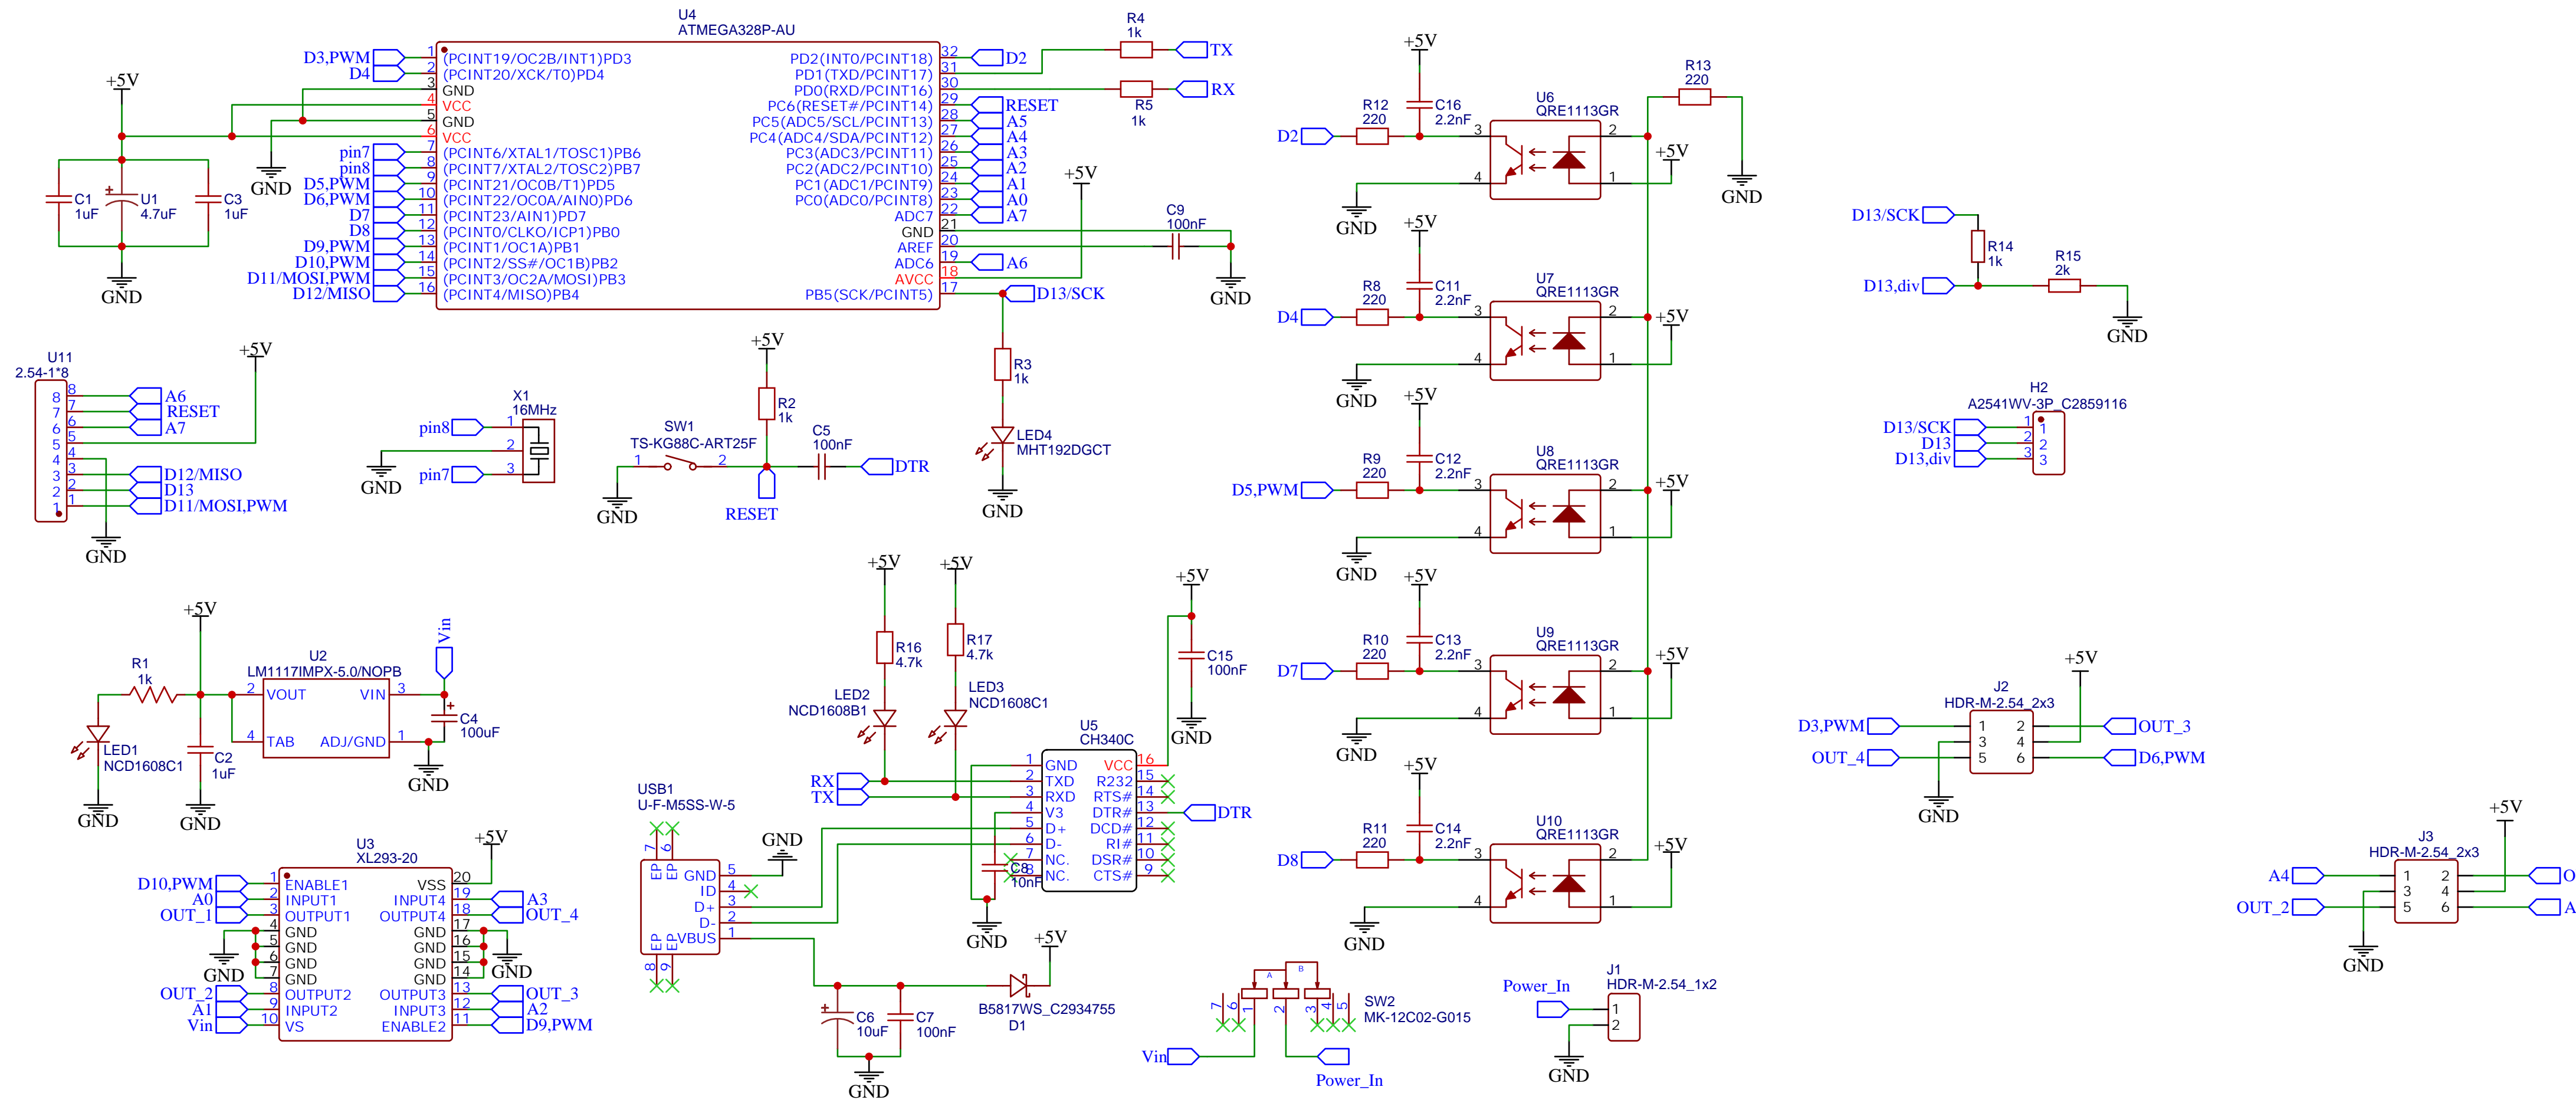
Use digital model for QRE sensor, less prone to noise and faster conversion than with ADC (analog)
From Polulu forum, digital performs better

Change Log:
2024/02/18 - Changed crystal to ceramic resonator and changed D1 to shottky diode
2024/04/05 - Changed 220 ohm res. and U3 capacitor for available stock
2024/04/20 - Changed U10 input 3&4 to A2 & A3
